Reference: N318/2024/RTC/01

**RE: Unit 1 & 2 - 77 Bassett Street, Mona Vale (DA2023/1841)**

**Development application for a proposed change of use to hand and power tools store - Response to Council on traffic and parking matters**

UNIT 1 & 2, 77-79 BASSETT STREET, MONA VALE  
 SWEPT PATH ASSESSMENT  
 8.8m LONG MRV ACCESSING THE LOADING AREA  
 DRAWING REF NO. N318-SP02

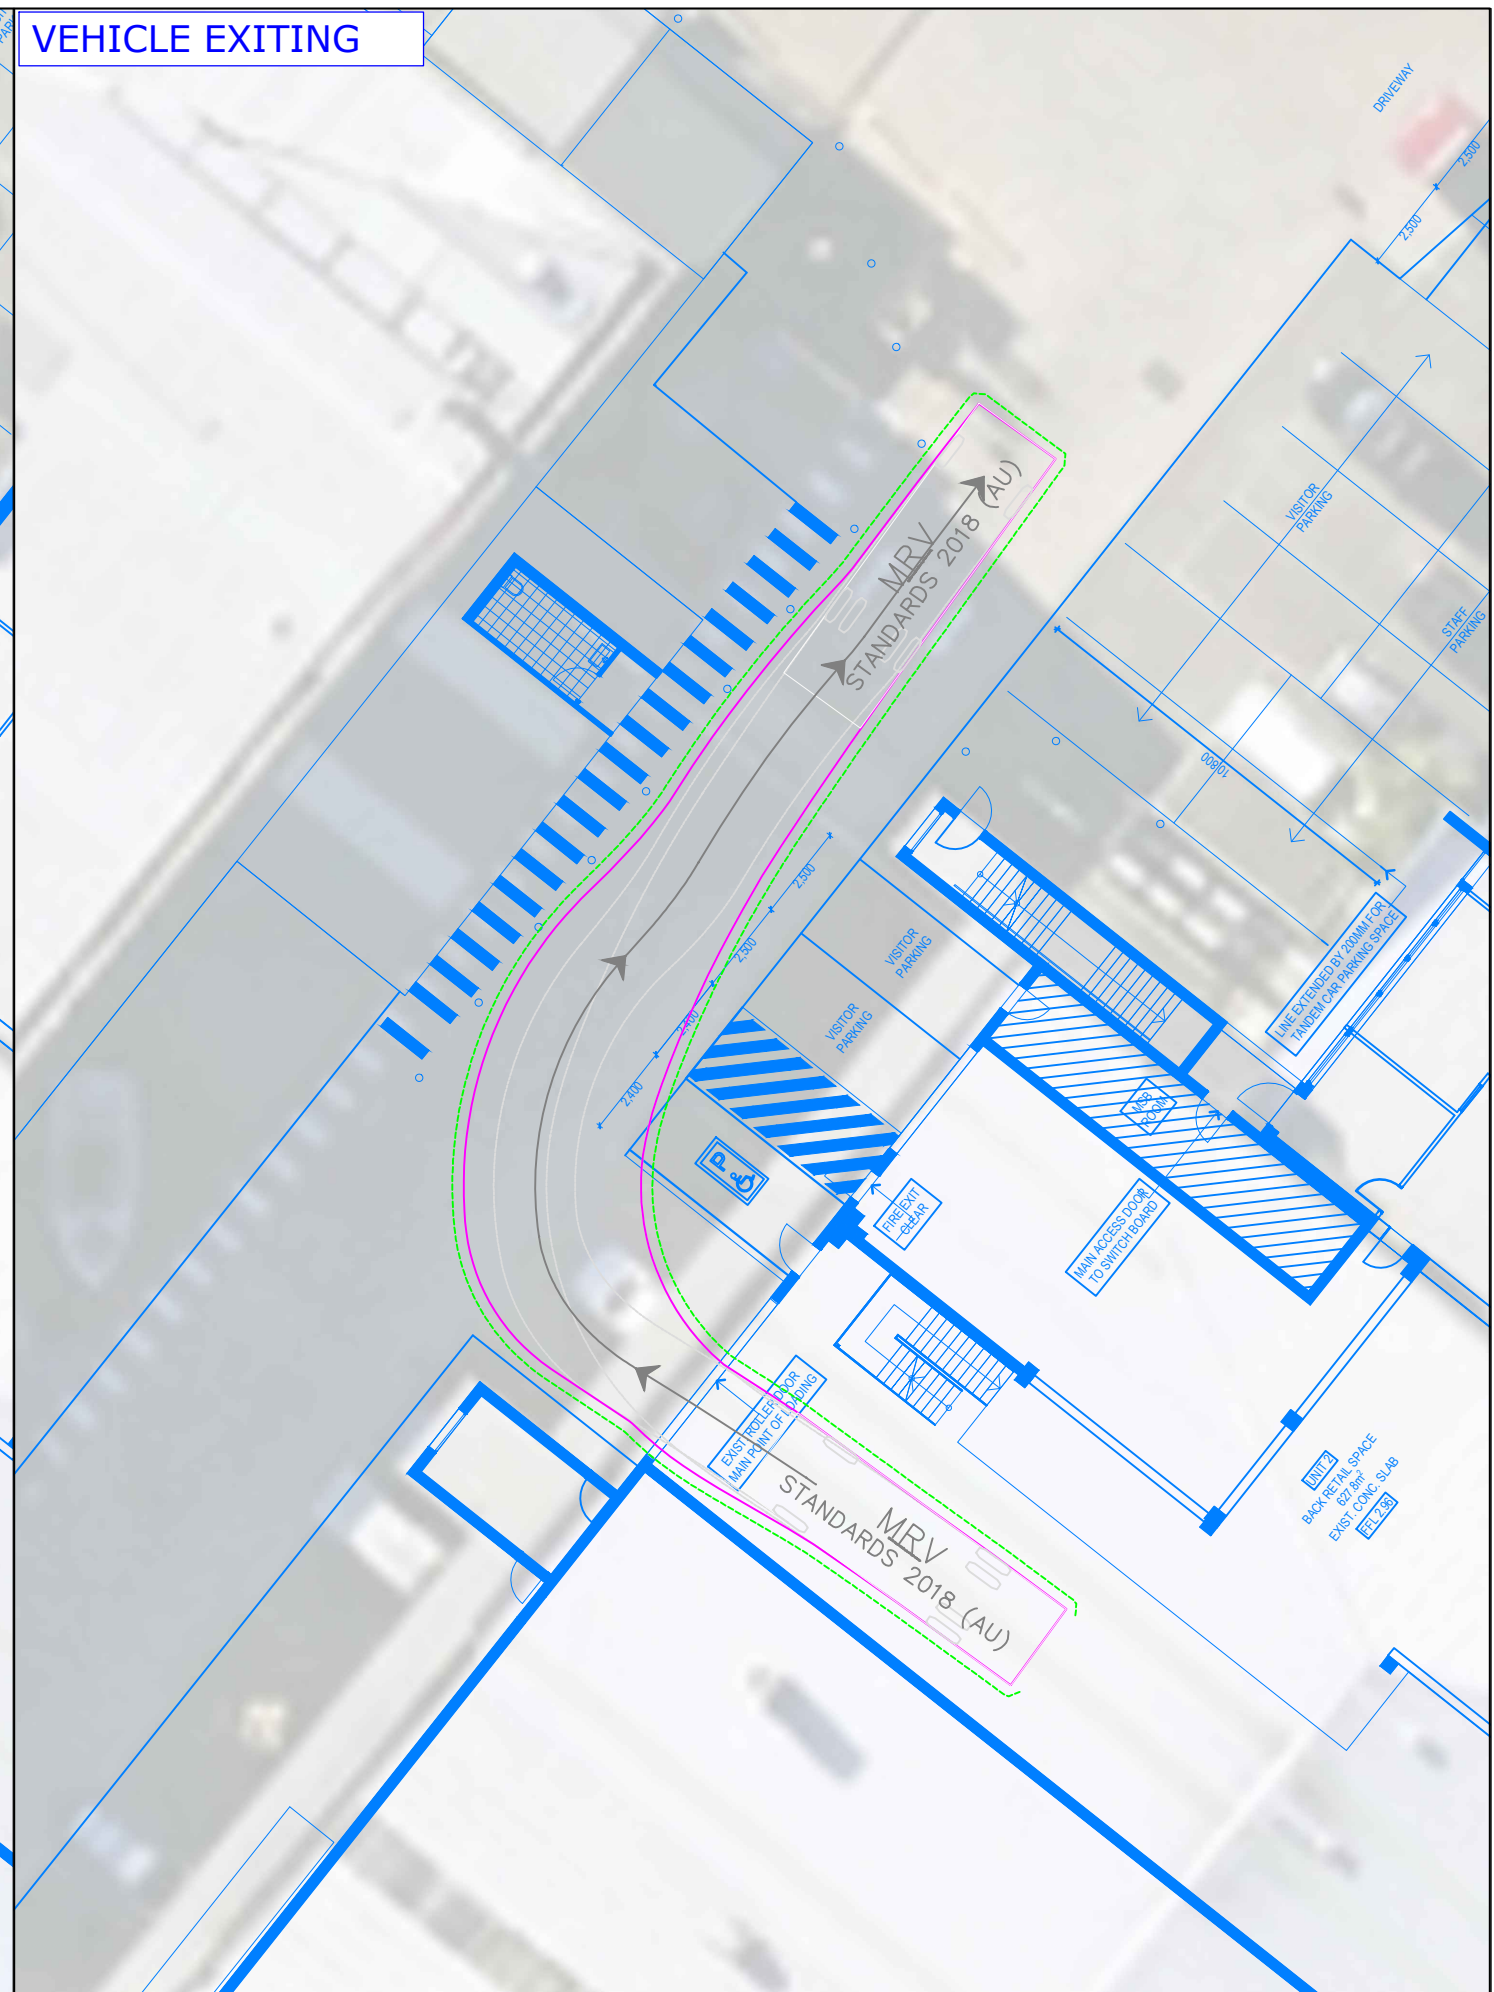
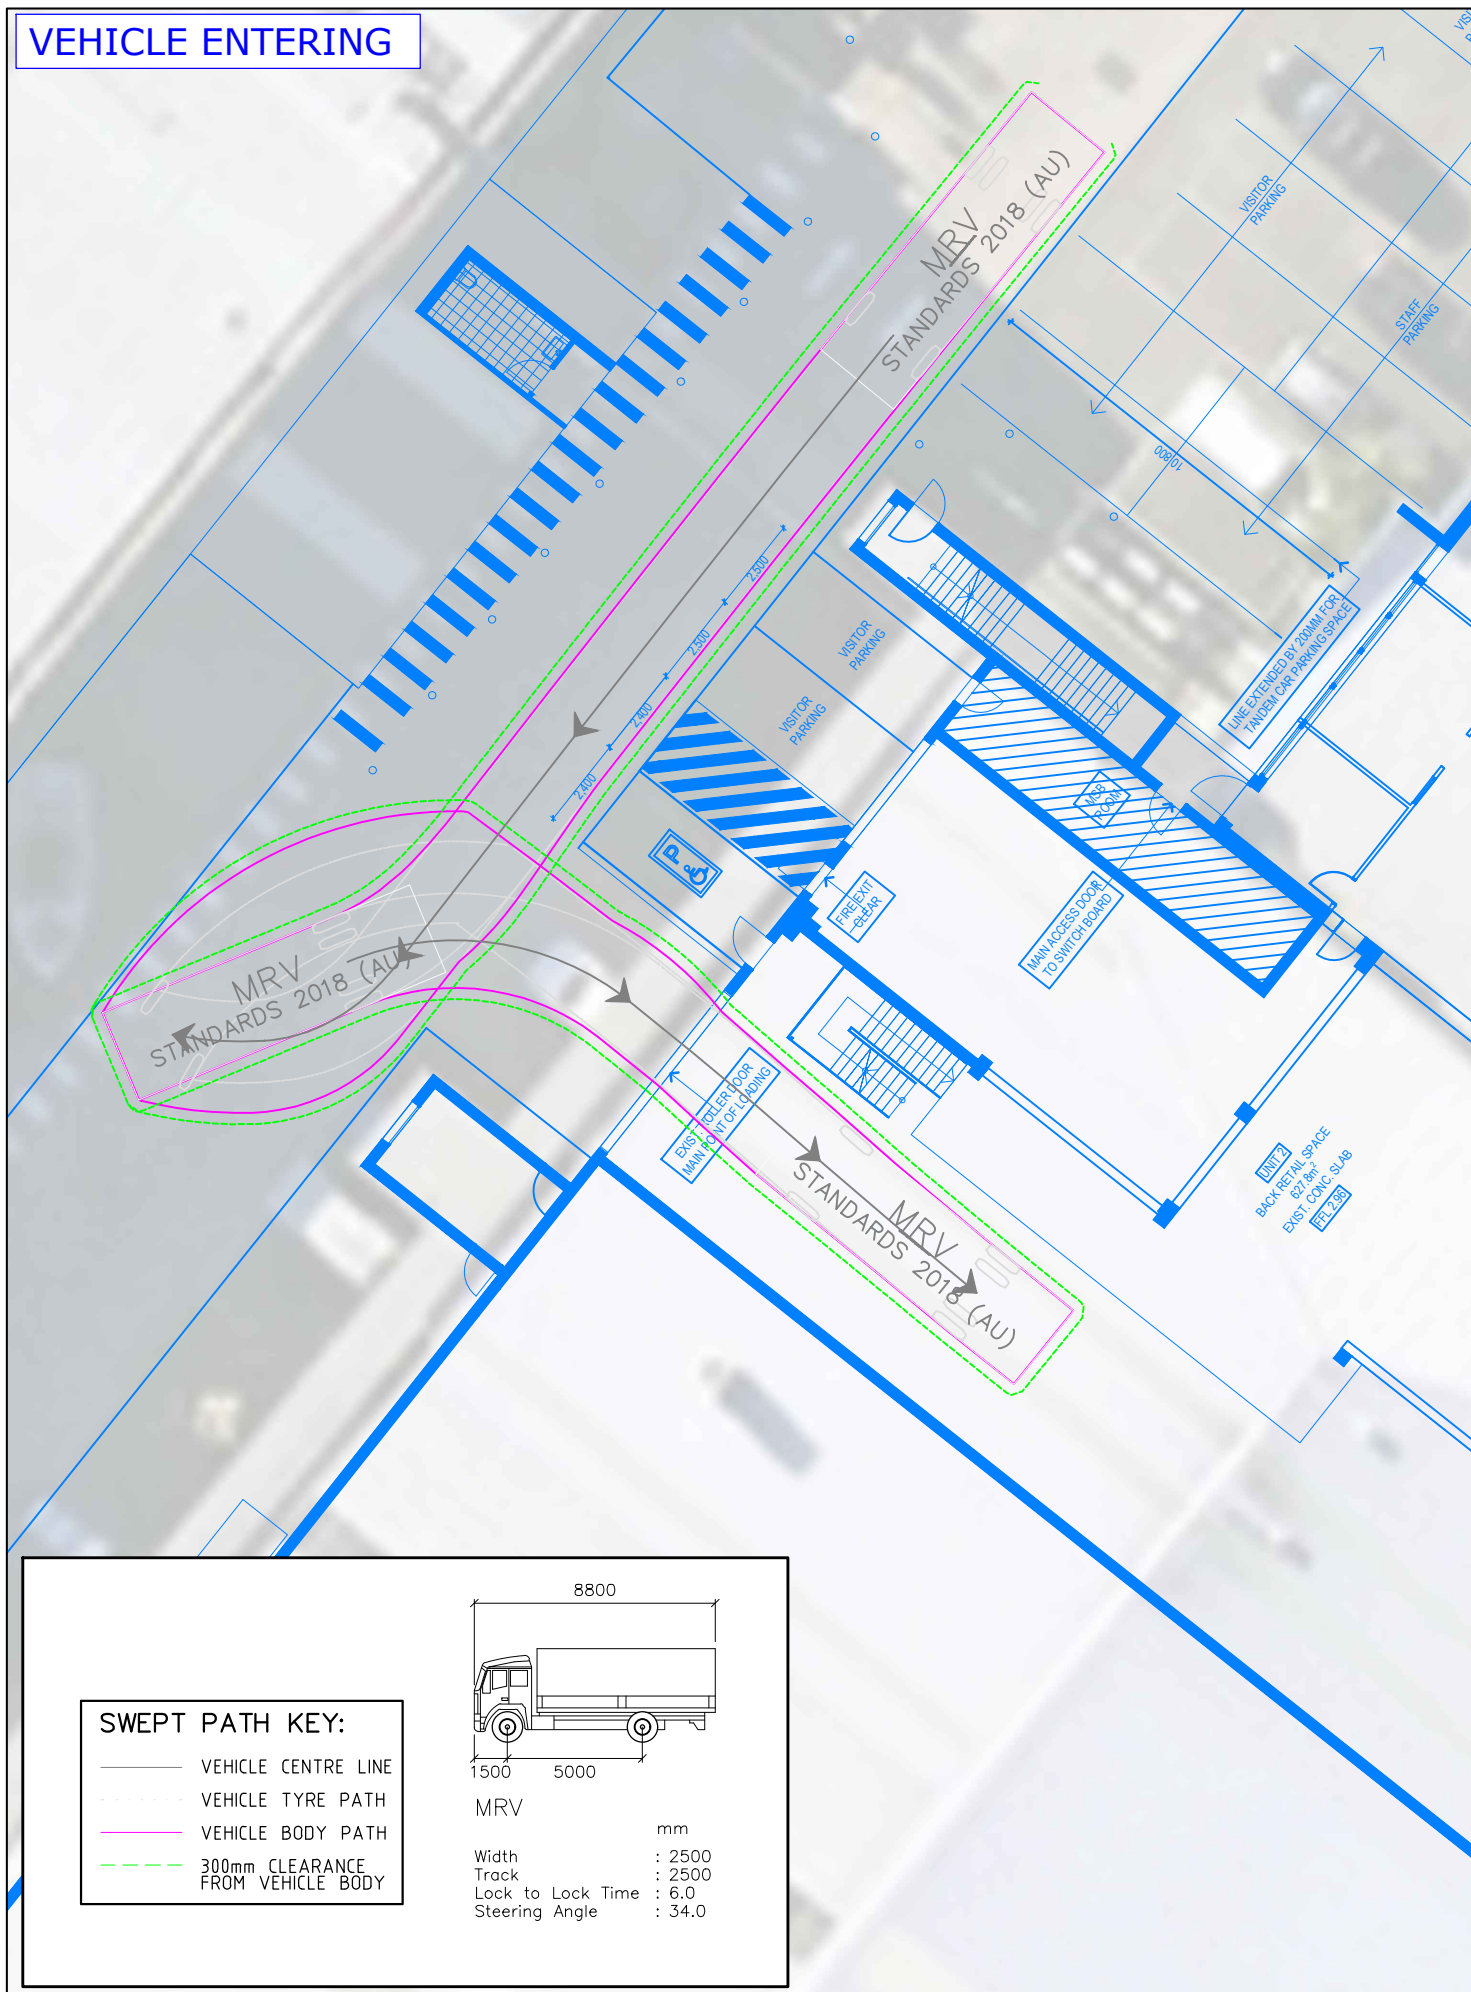
- *The traffic report mentions that some customer spaces will be closed off while MRVs ingress/egress the loading bay. The traffic report advises that swept paths showing this are attached in Appendix E. The traffic report is missing Appendix E containing the swept path, these should be provided. Furthermore, a Loading Dock Management Plan will be required to ensure that deliveries are appropriately scheduled and timed so as not to result in congestion either within the loading dock or in the carparking area. Ideally physical separation of loading/unloading activity from customer areas should be achieved but if that is not feasible time of day separation will be considered to ensure that loading activities occur outside hours when customers will be accessing the site*

- A swept path assessment of loading vehicles entering and exiting the loading area is provided in Attachment B of this letter. Based on the swept path assessment an 8.8 Medium Rigid Vehicle (MRV) will encroach into the proposed disabled parking space on its way out of the loading area. Therefore, in consultation with the client, it is determined that all loading/unloading activities involving an 8.8m long MRV truck would occur outside of operational hours.

- It is noted that Units 1 and 2 are currently approved to carry out deliveries, waste, and recycling collection between 7:00am and 8:00pm. Therefore, all loading activities involving an 8.8m long MRV will occur after the close of operations (i.e. between 5:30pm and 8:00pm). As such, this loading dock management arrangement can form part of the consent conditions.
